Re: Additional Information Requested for Chamisa CAES at Tulia, LLC  
Greenhouse Gas (GHG) Prevention of Significant Deterioration (PSD) Permit  
Tulia, Swisher County, TX

Thank you for providing the February 11 Application Completeness Determination and request for additional information. This letter provides our response to the February determination.

Updated Pages of PSD Permit Application for  
Chamisa CAES at Tulia, LLC

Figure 1. Heat Rate and Emission Data at Different Operating Loads

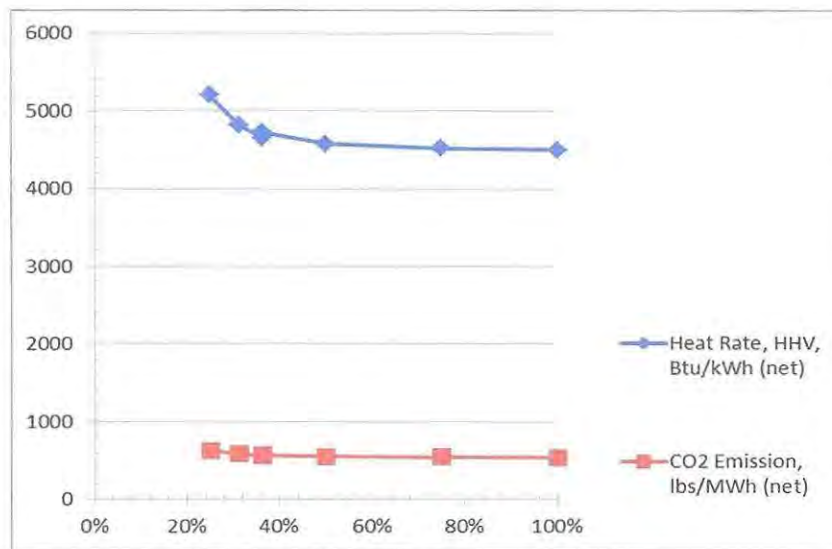
3. On page 36 of the permit application, in Table 7 entitled "Proposed Emission and Production Limits," there are two proposed limits for the turbine. Please provide supplemental data to explain the rationale for proposing the following limits: 550 lbs CO<sub>2</sub>/MWh (net) at maximum load and 620 lbs CO<sub>2</sub>/MWh (net) at any load from 25% to 100%. The limits appear to contradict the other. It is not clear the difference between "maximum load" and "100% load". Please provide an explanation for terms and the mode of operation. Also on page 32, it is stated that the Chamisa Facility will achieve heat rates over a range of plant operating rates of 50% - 100% of 4511 — 4674 (HHV) BTU per net kWh produced. Please provide a proposed BACT limit for the turbines that takes into account load fluctuations and performance degradation between overhauls. Please provide the calculations and the rationale that indicates operating these turbines at the heat loads used in the calculations is energy efficient as BACT. Please provide data for the combustion turbine that includes heat load and efficiency data that was selected. (This information can be graphically represented). What is the company's proposed compliance monitoring methodology for this limit?

Chamisa Response: Based on the updated performance data received from our turbine supplier, the values for CO<sub>2</sub> emissions per unit of power produced have been updated to be 540 lbs CO<sub>2</sub>/MWh (net) at maximum load, and 630 lbs CO<sub>2</sub>/MWh (net) at any other operating load. The proposed limit for maximum load reflects the limit at 100% load. The limit proposed for the

range of loads from the lowest sustainable load of 25% to the 100% load reflects the highest production rate of CO<sub>2</sub> over the full operational range. These values reflect a maximum 3% deterioration in turbine performance between overhauls. Our proposed emission levels for compliance monitoring were intended to establish the maximum load limit as a level which would be demonstrated in initial performance testing. The limit over the full performance range would then be established as the highest value expected over the full load range. The proposed limit for the full performance range is only 16.7% above the level achieved at maximum load.

Over the operating range of 50% to 100% load, the updated vendor performance data indicate a heat rate of 4502 to 4581 BTU (HHV)/kWh (net). At lower loads, the heat rate would gradually increase to a maximum of 5206 BTU (HHV)/kWh (net) at the lowest sustainable load. Because the emission limits in lbs of CO<sub>2</sub>/MWh directly measure and reflect overall process efficiency, we do not propose additional limits on heat rate itself as permit limits.

Vendor data and calculated parameters for turbine performance are tabulated below and also graphically portrayed on the next page.
